ALERT SERVICE BULLETIN
Bell Helicopter **TEXTRON**

NO. 206L-05-137

DATE Nov 08, 2005

SUBJECT: TAIL ROTOR TRUNNION HOUSING SEAL 535642
INSTALLATION, ONE-TIME INSPECTION OF

Figure 1 Correct orientation of seal in housing assembly

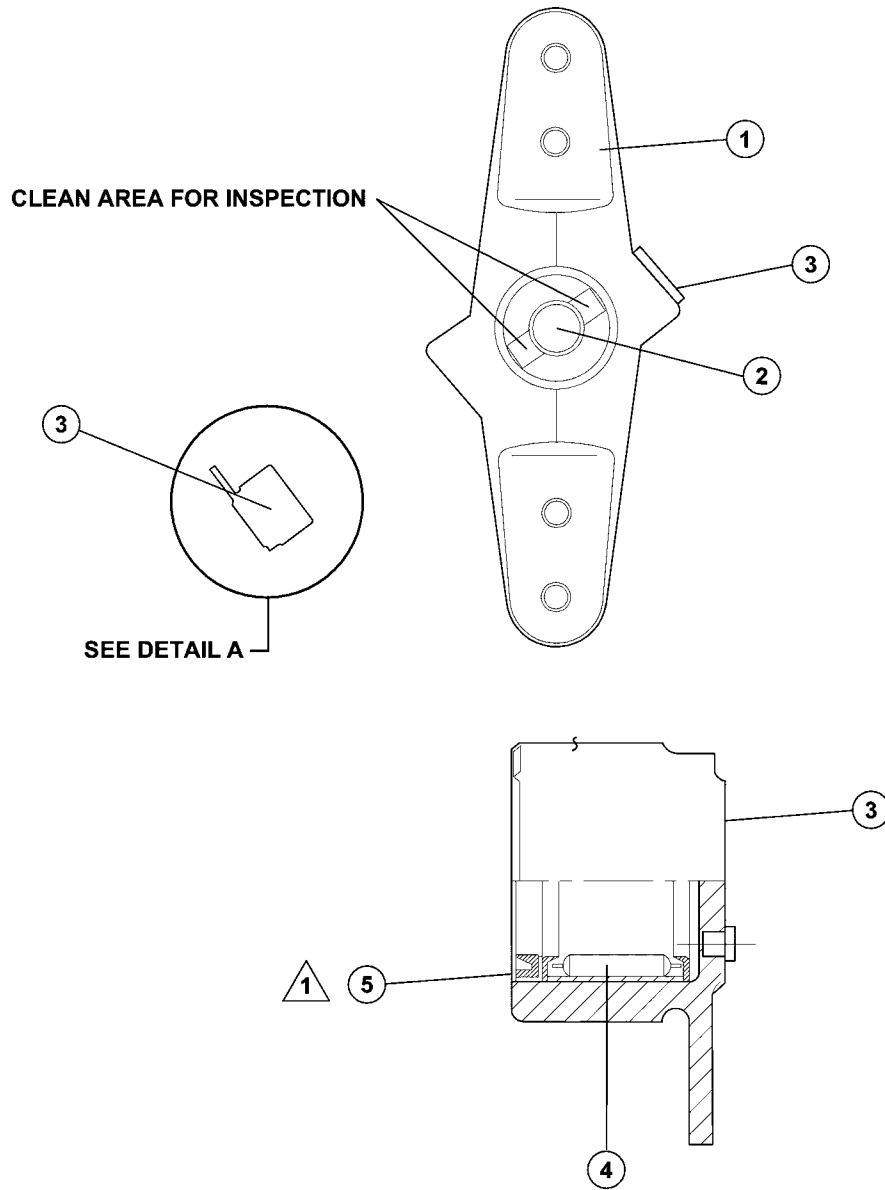
1. Inspect new housing assembly (3, Figure 1) not installed in a hub assembly (1) for correct seal (5) installation. If the housing assembly (3) is found with the seal (5) incorrectly installed, return the defective housing assembly (3) to Bell Helicopter and order a new housing assembly (3).
2. Inspect new housing assembly (3) installed in tail rotor hub assembly (1) for correct seal (5) installation. If the housing assembly (3) is found with the seal (5) incorrectly installed, perform PART III a. of this Alert Service Bulletin.
3. Inspect housing assembly (3) installed in a hub assembly (1) with time in service for correct seal (5) installation. If the housing assembly (3) is found with the seal (5) incorrectly installed, perform PART III b. of this Alert Service Bulletin.

1. Using a hand grease gun, purge grease (C-001) from bearing (4), by pumping grease into fitting, NAS 516, of housing assembly (3).
2. If normal purging of grease (C-001) from the bearing (4) can be achieved and the seal is not pushed out of the housing assembly (3) during lubrication, the seal performance in the new housing assembly (3) is acceptable and the helicopter may be returned to service. Make an entry in the Helicopter Records to show that Part II of this Alert Service Bulletin has been accomplished.
3. If restriction is felt and no grease is being purged from the bearing (4) through the seal (5) lip, perform PART III c. at your convenience but no later than the next scheduled lubrication.

NOTE
 Lip of seal facing toward the tail rotor gearbox output shaft.
Correct installation shown.

1. Replace the housing assembly (3) if the seal is found to be reversed. Refer to the BHT-206L-CR&O. Make an entry in the hub assembly historical records to show that the PART III a. of this Alert Service Bulletin has been accomplished.

1. Replace the housing assembly (3) and both trunnion (2) inner races if the seal is found to be reversed. Refer to the BHT-206L-CR&O. Make an entry in the hub assembly historical records to show that the PART III b. of this Alert Service Bulletin has been accomplished.

1. Remove the tail rotor hub and blade assembly from the helicopter. Refer to the applicable M206L Maintenance Manual.
2. Replace affected housing assembly (3) and both trunnion (2) inner races. Refer to the BHT-206L-CR&O.
3. Re-install the tail rotor hub and blade assembly on the helicopter. Refer to the applicable M206L Maintenance Manual.
4. Ground-run the helicopter and perform a tail rotor balance check. Refer to the applicable M206L Maintenance Manual or the TB 206L-96-187.
5. Make an entry in the Helicopter and the Component Historical Records to show that Part III c. of this Alert Service Bulletin has been accomplished.
